# D.P.U. 20-80 Alternative Regulatory Proposal Comments

May 6, 2022

## Re: D.P.U. 20-80, Investigation by the Department of Public Utilities on its own Motion into the role of gas local distribution companies as the Commonwealth achieves its target 2050 climate goals

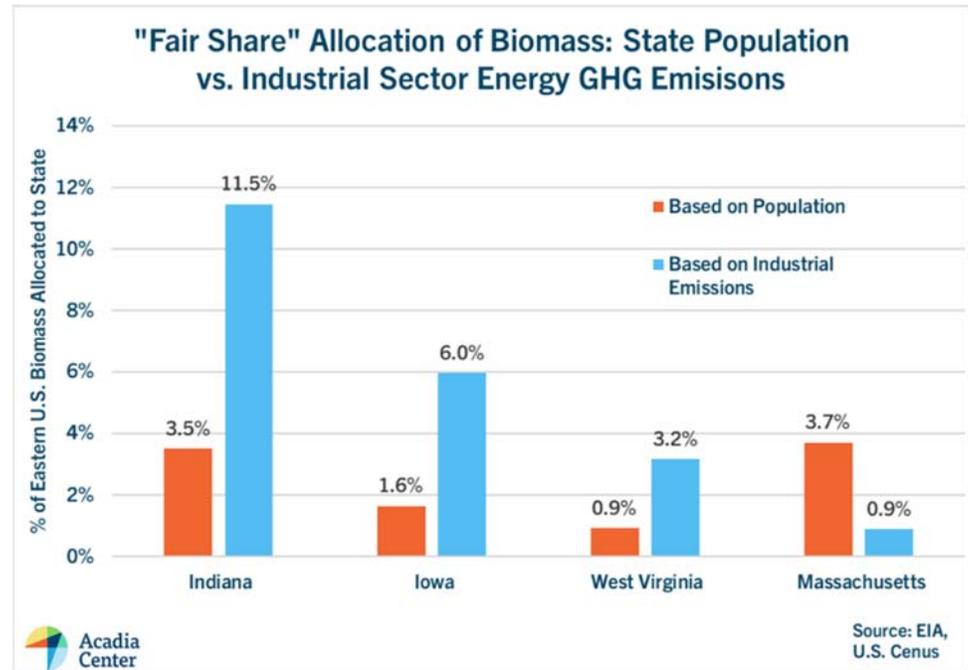
This population-weighted approach fails to account for the critical point that states with a disproportionate concentration of hard-to-electrify sectors, like heavy industry, will need more biomass to achieve carbon neutrality. A simplified example of this dynamic is shown in the figure here.

The orange columns show an allocation of biomass energy resources based on state population, as E3 has assumed. The blue

columns show an allocation of biomass based on current industrial sector emissions in each state.

**As an example, Indiana's population is lower than that of Massachusetts, yet industrial energy demand in Indiana is nearly 13 times higher than industrial energy demand in the Commonwealth.**<sup>21</sup> Allocating a "fair share" of biomass to states based on industrial sector energy consumption would result in bioenergy resources for Massachusetts being significantly more constrained than E3's model assumes.

**In Massachusetts, notice how this tweak to biomass allocation reduces the amount of biomass, and thus RNG, available to Massachusetts by over 75%.** If E3 allocated biomass resources based on industrial emissions in each state, the scenarios that rely heavily on RNG would simply fall apart due to a lack of RNG supply. The population-based allocation E3 assumed is very convenient if one is trying to make the case that RNG will be plentiful in Massachusetts, but not-so-convenient for industry-heavy states like Indiana that get shortchanged by this approach.

**Figure 15. Gas throughput and composition over time (TBTU). Chart portrays cases with optimistic renewable gas assumptions. High hydrogen demand in the Efficient Gas scenario is a result of dedicated hydrogen pipelines to commercial buildings and industry.**

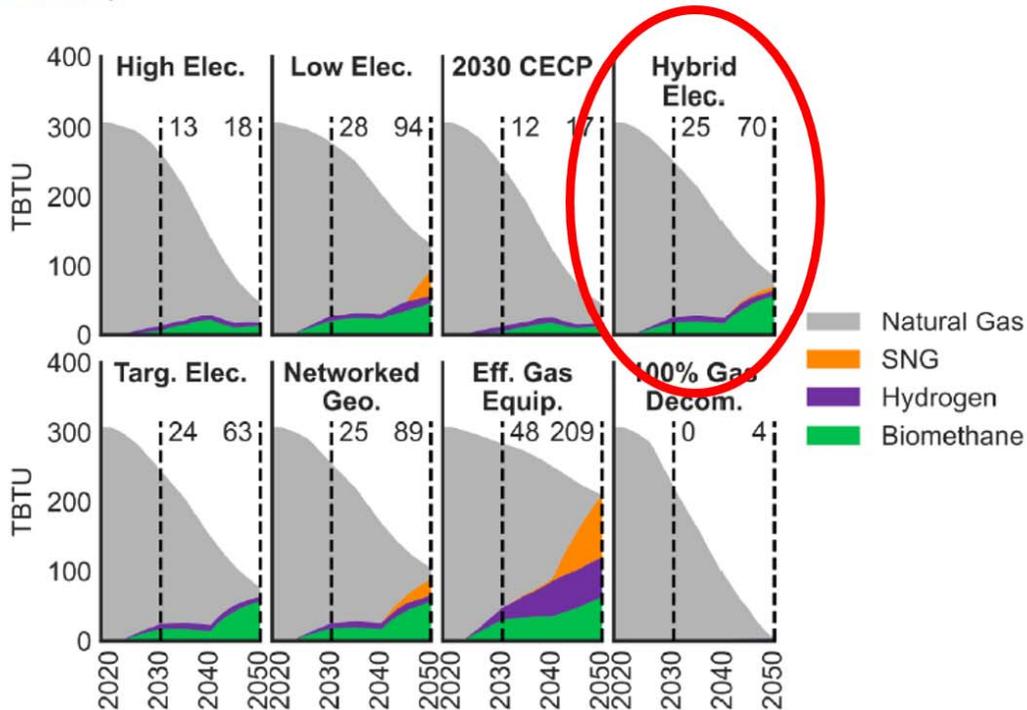
It’s important to note that the figure above is using E3’s “optimistic renewable gas assumptions” that assume “Biomethane is sourced through both anaerobic digestion and gasification. Lower hydrogen and SNG costs are driven by optimistic electrolyzer costs.”<sup>25</sup> A version of the above figure using E3’s “conservative renewable gas

assumptions” was not made available by E3. However, if this figure did exist it would show a significantly heavier reliance on SNG across scenarios, as RNG supplies would be exhausted much earlier. This is a result of the conservative assumptions ruling out the use of biomass gasification (a form of “intentionally produced methane”) to produce RNG.

Data provided by E3 for the Efficient Gas Scenario demonstrates the stark difference in reliance on SNG between scenarios assuming optimistic vs. conservative renewable gas assumptions. Under optimistic assumptions, SNG makes up 54% of total energy delivered through the gas distribution system by 2050 in the Efficient Gas Scenario, but under conservative assumptions SNG makes up 83% of the total by 2050.<sup>26</sup> The same data was not provided for the Hybrid Electrification scenario, but one would see a similar dynamic at play.

**Figure 9. Renewable gas supply curves in 2050 for optimistic and conservative Efficient Gas scenario.**

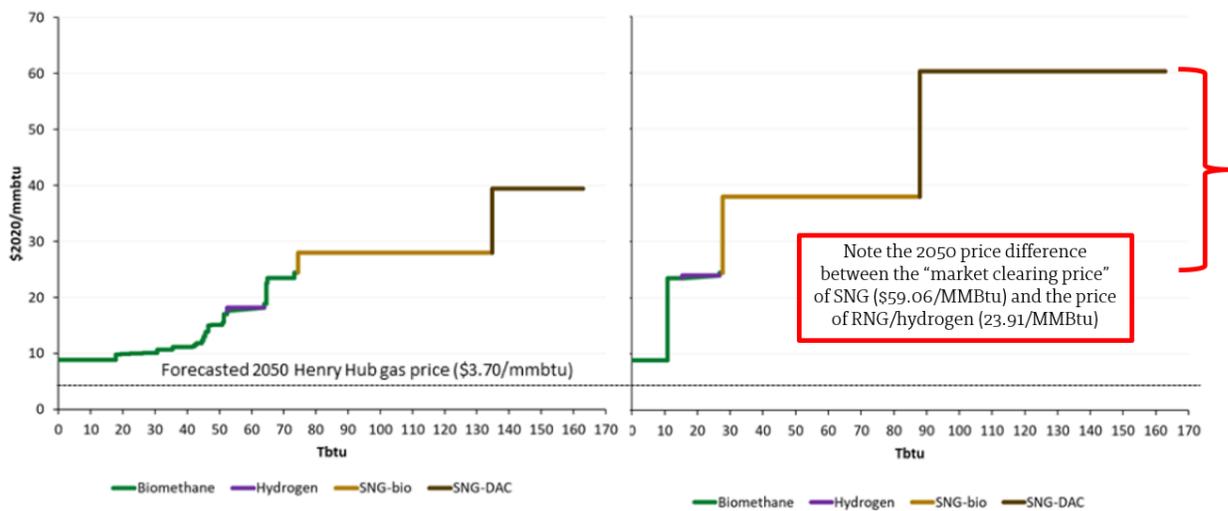
Take the example of the Efficient Gas scenario with conservative renewable gas assumptions (see figure above and table below). **E3 is assuming that, in 2050, the LDCs are simultaneously obtaining SNG at a cost of \$59.06/MMbtu and RNG and hydrogen at a cost of \$23.91/MMbtu.<sup>29</sup> Why would Producer A sell RNG to the LDCs at 40% of the price that Producer B is selling chemically-identical SNG to the LDCs?** Producer A is just leaving money on the table – this isn’t how markets actually work. E3 attempts to justify this modeling decision by mentioning that the LDCs will enter bilateral market contracts for SNG, but this explanation doesn’t hold up. Even if the LDCs did enter bilateral contracts for SNG, what is to prevent suppliers of RNG from raising their prices to match the prices of SNG agreed upon in the bilateral contracts? E3 dedicated one sentence in the entire report to this critical modeling decision.

In the Efficient Gas scenario, if E3 took the correct approach of having the most expensive unit of SNG set the market clearing price for all three alternative fuels, the per unit cost of the LDCs obtaining RNG and hydrogen would increase 147% from the price E3 is currently assuming. The price of obtaining SNG-Bio (SNG produced using CO<sub>2</sub> from biorefineries) would increase 59%. As summarized in the table below, **E3’s decision to treat SNG as a separate market in the Efficient Gas Scenario underestimates the cost of the LDCs obtaining alternative fuels in the Efficient Gas scenario by \$2.29 billion per year in 2050.**

**Figure 2. Cumulative (simple sum) energy system costs relative to reference by decade (\$2020, billion). Demand-side capital costs include all incremental consumer costs, including heating appliances, building shell retrofits and the cost of EVs.**

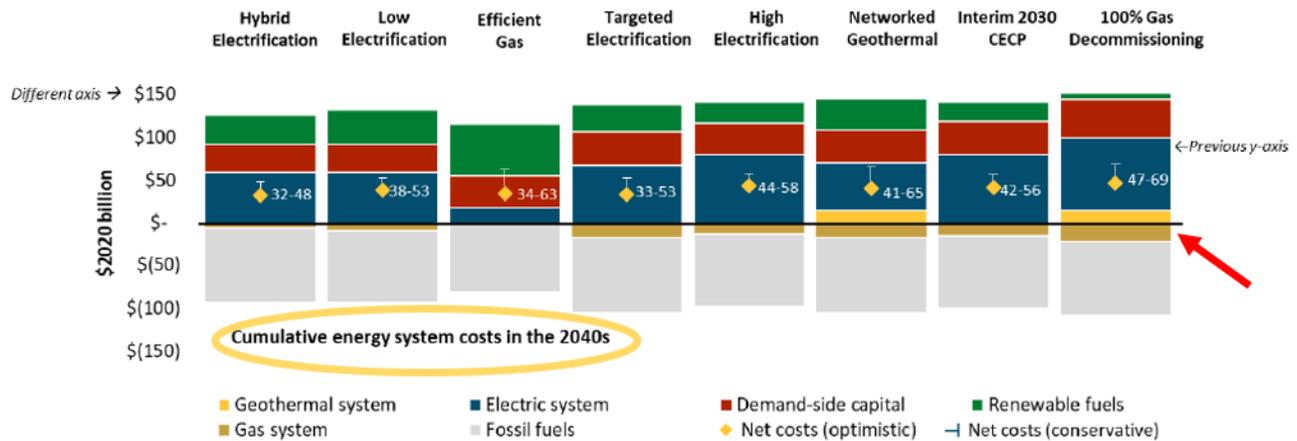
Take, for example, the “100% Decommissioning” scenario that envisions a fully decommissioned gas system by 2050. It intuitively makes sense that a large portion of the avoided costs from this scenario would occur post-2050, when past investments in the gas system have become fully depreciated and Massachusetts ratepayers are no longer responsible for the costs associated with maintaining an extensive gas system (because that gas system has been fully decommissioned). Yet, because the analysis made the arbitrary decision to only consider costs over the next 28 years, it doesn’t provide any insight into post-2050 energy system cost comparisons across scenarios.

Figure 5. Transformation of residential space heating stocks.

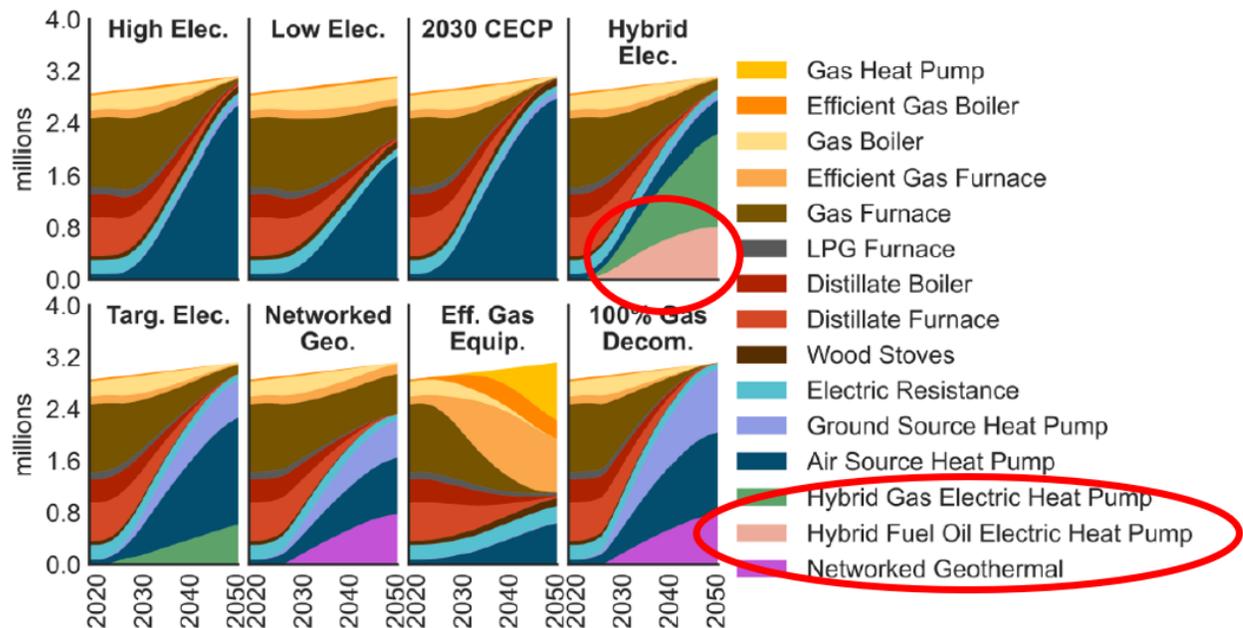
When reviewing E3’s Hybrid Electrification scenario, one thing that jumps out is the heavy reliance on hybrid fuel oil/electric heat pump systems (i.e., buildings that serve a portion of their space heating demand from a heat pump and the remaining portion of from a fuel oil back-up system that uses 100% biodiesel by 2050). Figure 5 from the Independent Consultant Report Appendix 1 below highlights the heavy reliance on hybrid oil systems in the residential sector out to 2050.<sup>44</sup>

The Hybrid Electrification scenario is the only scenario in the E3 report that uses hybrid oil heating systems.
